**PREVOST**

**WARRANTY  
BULLETIN**

**WB14-39**

DATE :	SEPTEMBER 2014	SECTION :	22 - HVAC
EXPIRATION:	SEPTEMBER 2016		
SUBJECT :	POWER CABLE INSPECTION AND DECAL ADDITION

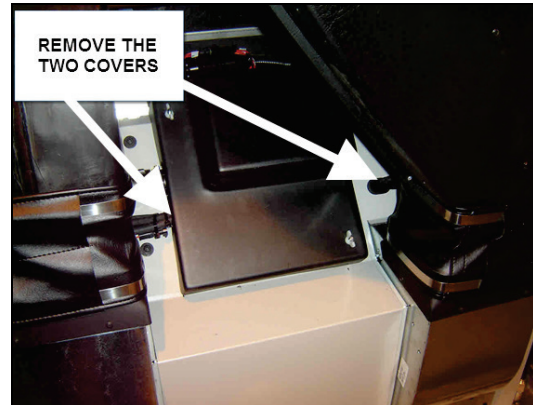
2. Inspect the power cable at location shown in picture.

3. Cut the cable tie on top of fan housing to create some play on the cable. Adjust to give proper clearance.

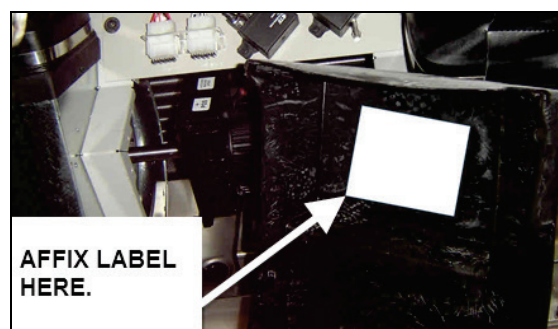
4. Clean cover with alcohol. Let dry.
5. Place label #069158 inside control box cover in this location. (arrow)
6. Re-assemble covers.
